Office Action Summary	Application No. 09/531,735	Applicant(s) LEVIN ET AL.	
	Examiner Árpád Fábán Kovács	Art Unit 3671

DETAILED ACTION

3. Claim(s) 9-22, new claims 33-35 are rejected under 35 U.S.C. 102(b) as being anticipated by Weber (part of record, 413).

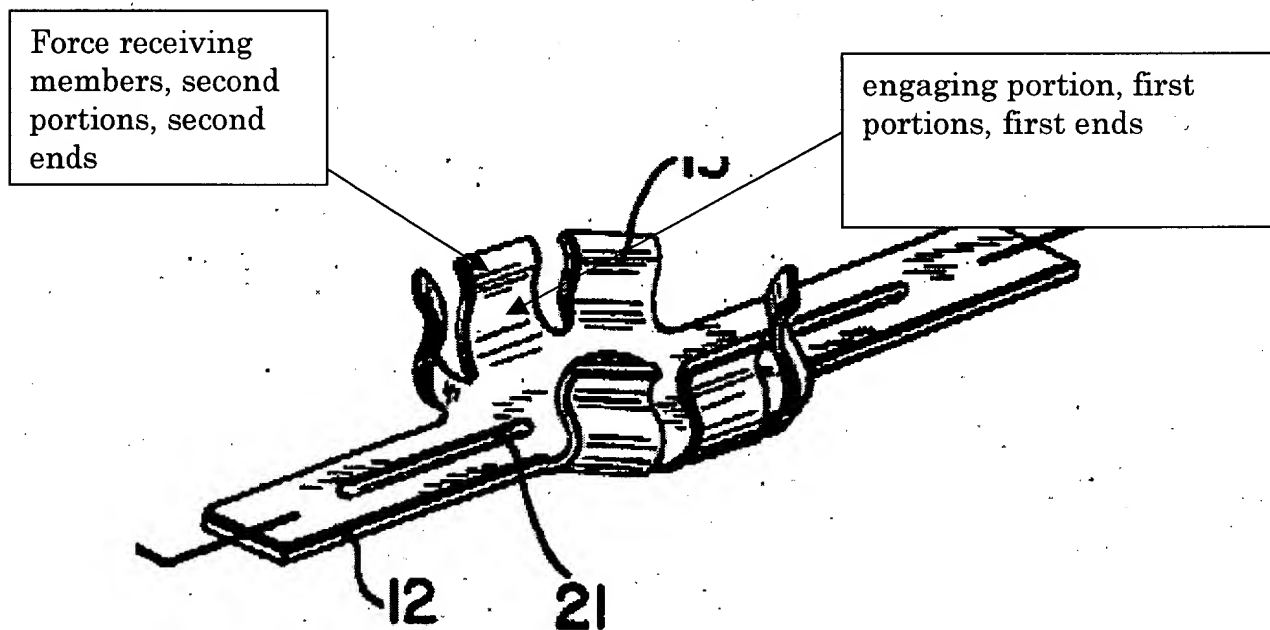
As shown in the marked up figures below, Weber discloses:

a stub (hub 14; groove 19 & cylindrical portion 20) in communication with shaft (fig 2);

flexible members (spring clips 13) including:

engaging portions and force receiving members disposed at opposite ends (see fig above);

Examiner does not agree with Applicant's characterization of ref. 93 as the "force receiving members." On page 9, line 16, ref 93 is disclosed to be a tapered end of ref 92.
